**BOARD OF ZONING ADJUSTMENT  
STAFF REPORT****Date: July 6, 2015****CASE NUMBER**

5981/4384/4357

Alabama Hotels, LLC

**LOCATION**251 Government Street  
(Southwest corner of Government Street and South  
Joachim Street)**VARIANCE REQUEST****SIGN:** Sign Variance to allow a non-painted wall sign, a corner wall sign, a wall plaque, and a vertical sign on a balcony in a T5.2 Sub-District in the Downtown Development District.**ZONING ORDINANCE  
REQUIREMENT****SIGN:** The Zoning Ordinance allows painted wall signs; however, corner signs, wall plaques, or vertical signs on a balcony are not allowed in a T5.2 Sub-District in the Downtown Development District.**ZONING**

CL primary building ID  
SCALE: 3/32\"/>

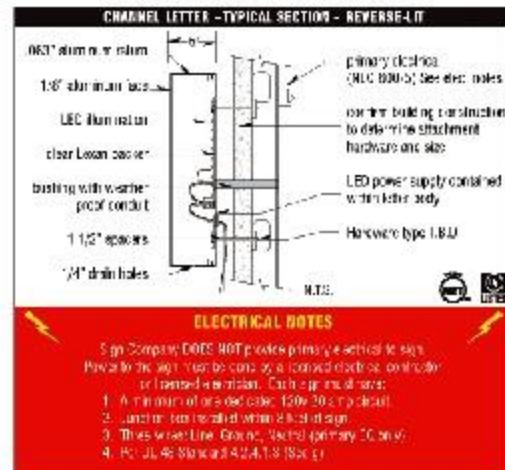
*"The Admiral" vertical sign:*

1. *The calculation for the square footage of the sign was not done by our office. However, the height and width determined were accurate to the original design for signage. However, it has been modified slightly to achieve the proper font scale.*
2. *The Owners expressed a concern that the signage needed to be visible from the interstate. We approached the building from several angles by car to determine the proper sign height and scale. A smaller sign simply isn't legible from a safe driving distance.*

*The size of the signage has been altered from the previous submission to either match what was submitted to the ARB, or slightly smaller. The large rear wall sign was approved by ARB as a 311 square foot sign, and the revised information submitted illustrates a 306 square foot sign. The wall sign that wraps around the Northeast corner of the building was approved by the ARB as a 15.6 square foot sign (per face), and is currently illustrated as 13.43 square feet. The applicant clarified that they wish to have two vertical balcony signs at 20 square feet per face which matches what was approved by ARB. The applicant further clarified that they are requesting two wall plaques which will be 4.7 square feet. It does not appear the wall plaques were reviewed by the ARB.*

2 sided wall sign to wrap corner

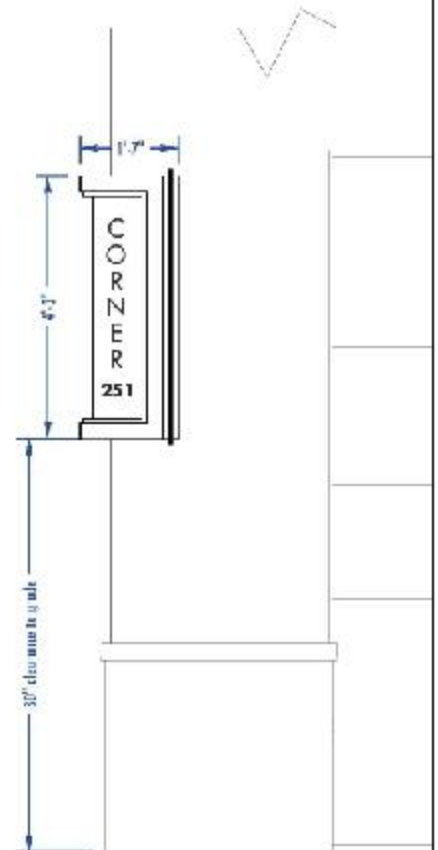
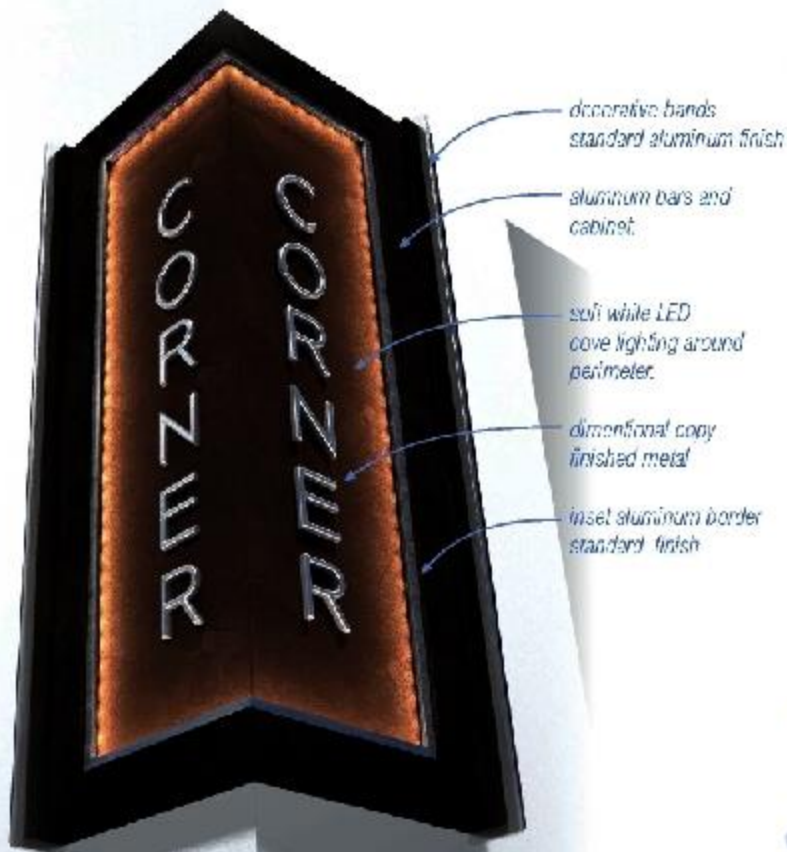
*Corner 251 sign:*

1. *The entrance to the Corner food and beverage outlet is visibly blocked by a large column that stands center of the double-door outside access to the establishment. We felt that wrapping a sign on the outside corner of the column was tasteful and subtle.*
2. *The success of this food and beverage outlet is mainly dependent on outside business. In times past, the hotel treated this outlet more as a service for the hotel than a standalone business. Therefore, the signage was not imperative at the outside access point. That practice is not sustainable with current hotel trends in food and beverage.*

*While the applicant has provided clarification as to the size and number of signs requested which more closely match what the ARB reviewed, they have still not provided sufficient justification as to the existence of a hardship associated with the site that prevents any kind of compliant signage allowed within the Downtown Development District. Regarding the large wall sign, there is no mention made of why the sign could not be painted on the wall with lights directed at the sign to allow night visibility which would be allowed by right. The proposed wall sign around the Northeast corner of the building could be reconfigured as a diagonal corner sign with up to 45 square feet per face and would allow for visibility by traffic from both*

*projecting sign (to existing post)*

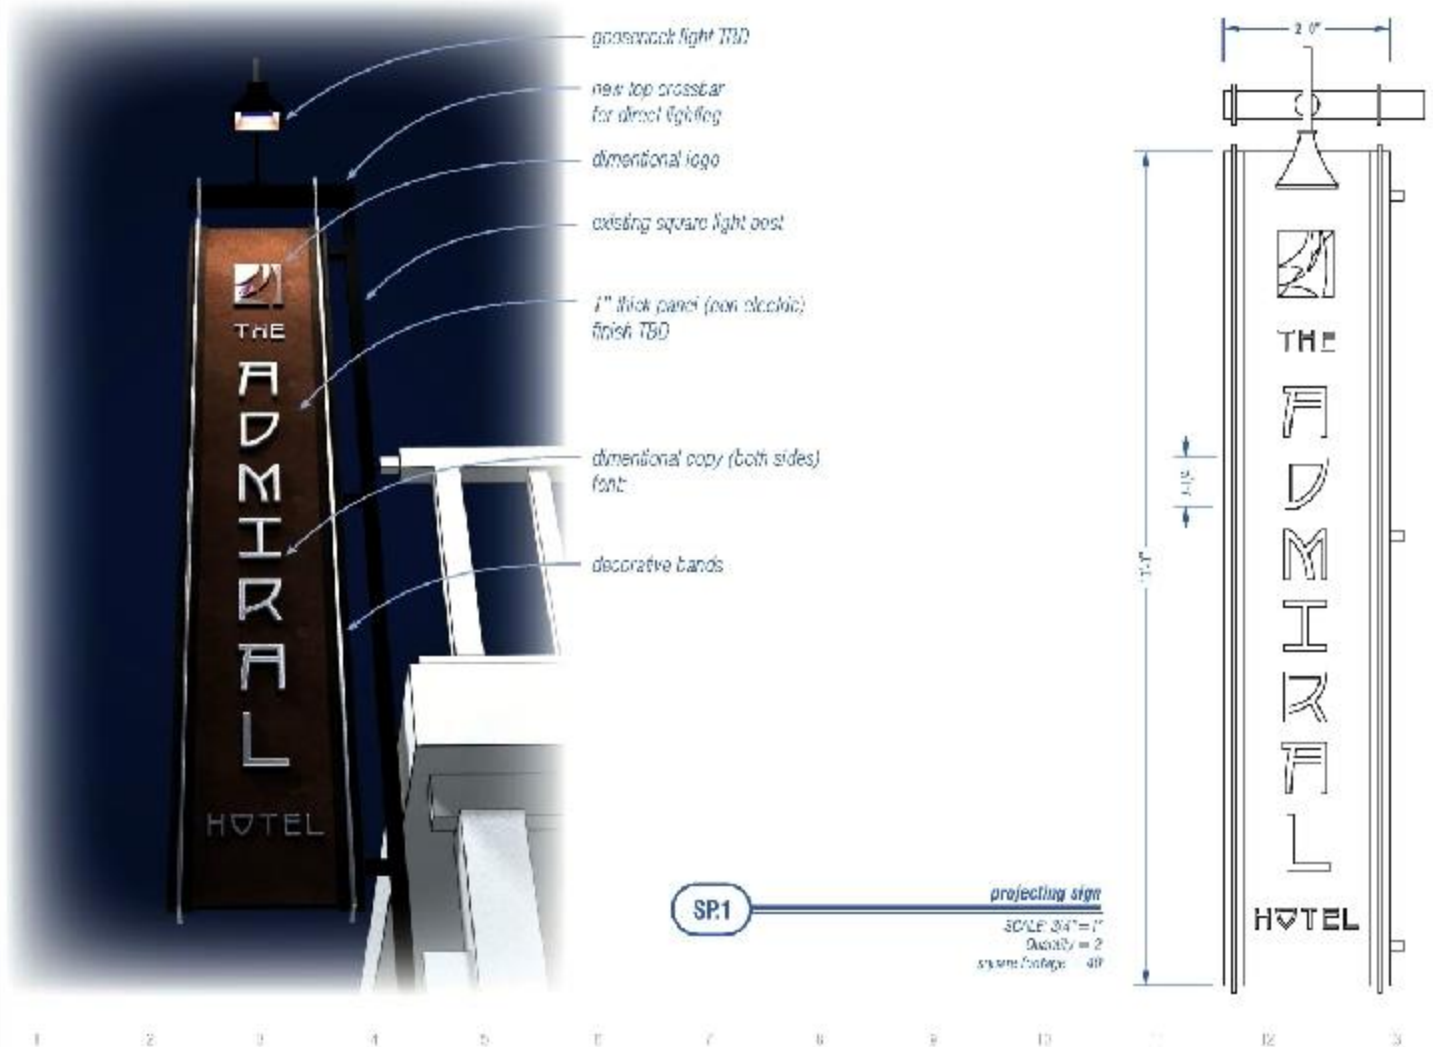
*Blade signs mounted on the balconies (Qty 2):*

1. *We wanted to create pedestrian scale signage for the Government St. and Joachim St. facades of the building. This was in consideration for the surrounding buildings and the relationship of this historic structure with these streets.*
2. *The large Spanish Oaks that line Government St. preclude passing traffic from identifying traditional plaque signage that would be mounted on the building.*

3. *There was a precedent in the signage ordinance that allowed for a corner-mounted 3' x 15' blade sign. A true corner location would not work with sightlines; we did not feel it was excessive to ask for 2 signs considering the corner location of the building. Most importantly, the location of the Joachim St. sign shows drivers-by on Government St. the location of the valet entrance to hotel.*

*directions as well as pedestrians. The vertical balcony signs proposed are discussed as being preferred versus wall plaque signage due to visibility concerns for traffic and pedestrians; however, there is no mention as to why a traditional hanging blade sign could not be successfully utilized. Finally, the wall plaques could possibly be redesigned to convey the same message as window decals depending on the proposed location of the signs on the building.*
